New Bosch Coil Design for BMWs – Where’s the “Snap?”

Newly-redesigned Bosch coils for BMWs, part numbers 0 221 504 464/00124 and 0 221 504 407/00044 have had a number of technicians and field installers wondering what happened to the “snap”.

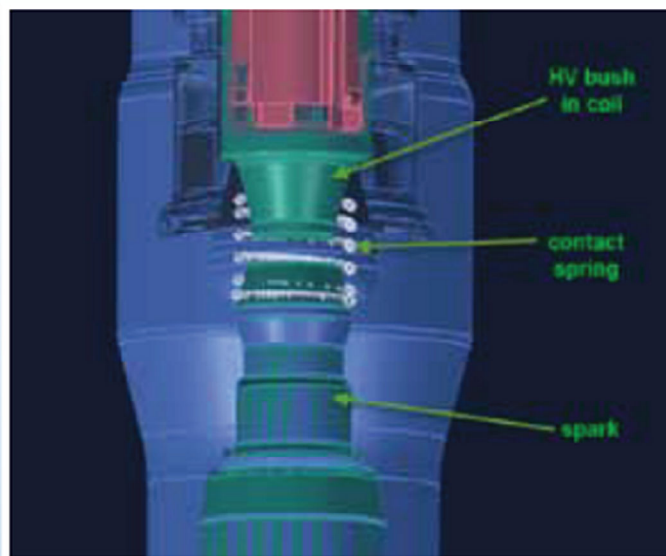
With the newly-designed coil, the customary “snap” is no longer heard nor is it an indication that the coil has been properly installed. This new design does, however, provide better coil performance at the spark plug connection point, which was the area that concerned some technicians. In other words, the original design actually gripped the spark plug tip and felt more secure; whereas the new design uses a contact spring on the spark plug tip and this design may not feel like the connector is gripping the spark plug, but in reality it does the job just as well or better than the old design.

Old design coil with catch mechanism producing “snap”

New design coil with HV bush in coil and contact spring
